## JOINT REGIONAL PLANNING PANEL (Sydney East Region)

JRPP No	2014 SYE060
DA Number	DA-2014/346
Local Government Area	ROCKDALE CITY COUNCIL
Proposed Development	Integrated Development - Demolition of existing structures and construction of a part five (5) & part six (6) storey residential flat building containing 78 residential units with 2 basement car parking levels and ground floor level car parking for 97 vehicles
Street Address	2-8 Loftus Street & 1-3 Edward Street, Turrella NSW 2205
Applicant	Benson McCormack Pty Ltd
Number of Submissions	First Public Notification period: seven (7) submissions from seven (7) property addresses Second Public Notification period (amended plans): five (5) submissions from four (4) property addresses
Regional Development Criteria (Schedule 4A of the Act)	Development that has a capital investment value of more than \$20 million.
List of All Relevant s79C(1)(a) Matters	<ul style="list-style-type: none"> <li>• List all of the relevant <a href="#">environmental planning instruments</a>: s79C(1)(a)(i) <ul style="list-style-type: none"> <li>- <i>State Environmental Planning Policy Building Sustainability Index (BASIX)</i></li> <li>- <i>State Environme

Figure 3. Height of Buildings map of subject site (shown highlighted in red) with the 12m building height marked as yellow and the 18m building height marked as light brown. Source: RLEP 2011

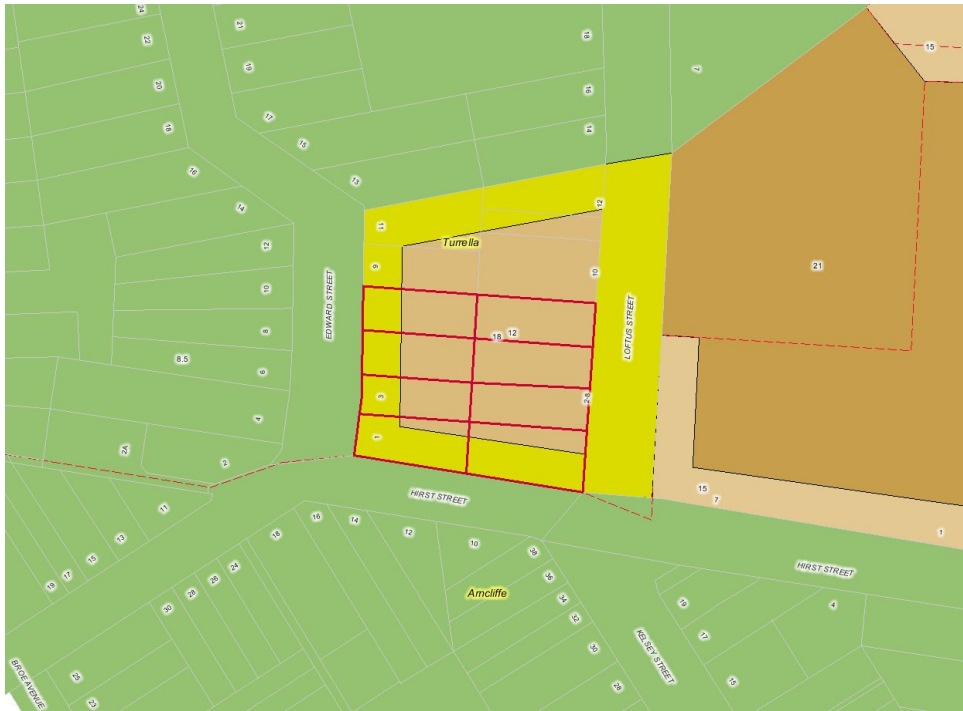
The original proposal does not comply with either of the 12m or 18m maximum height of building controls under Clause 4.3 of the RLEP 2011. The height of building non-compliances are in the order of 1.2m for the balustrades to the balconies of the fifth storey and to the building columns to the fourth storey for the part of the building along Hirst Street. The lift overrun structure to the south-eastern portion of the building along Loftus Street exceeds the maximum 18 metre building height by 4.77 metres. The part of the building located on the north-eastern portion of the building along Loftus Street exceeds the maximum 18 metre building height by 4.38 metres.

As a consequence of the proposed deferred commencement conditions, part of the building located on the north-eastern portion along Loftus Street and the lift overrun structure to the south-eastern portion of the building along Loftus Street will exceed the maximum 18 metre building height by 1.38-1.77 metres. As amended, the proposal is subject to Clause 4.6 variation to the height of the building standards and is supported for the reasons outlined in this report.

- The breach of the 18m building height across the Loftus Street frontage is not considered a detrimental planning outcome to the adjoining properties along Loftus Street, and does not result in significant loss of views or adverse privacy impacts on the streetscape from the bulk and scale of the buildings.

Figure 4. Street Section diagram

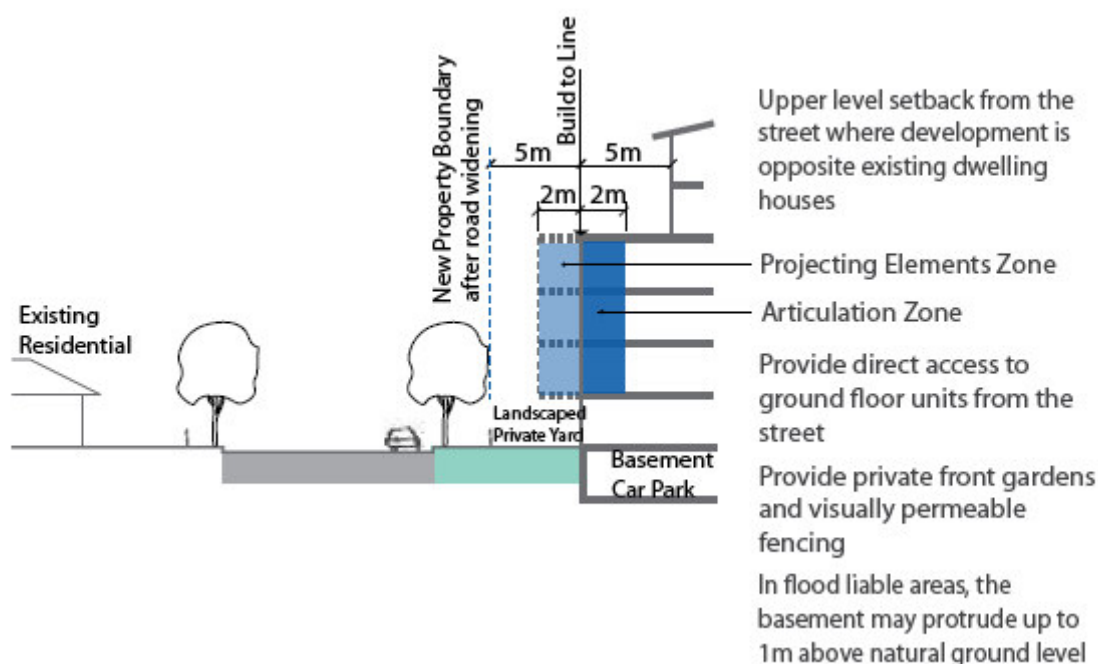
*Part 7.2.7 Incorporate setbacks at the street frontage in accordance with the street section diagram (see Figure 3 below)*

Given that the ground floor level is raised to combat flood planning levels, appropriate provision is provided in the form of steps and ramps in order to enable ground level pedestrian entries. As a result of the above access requirements, the development has been raised and setback at the ground floor levels.
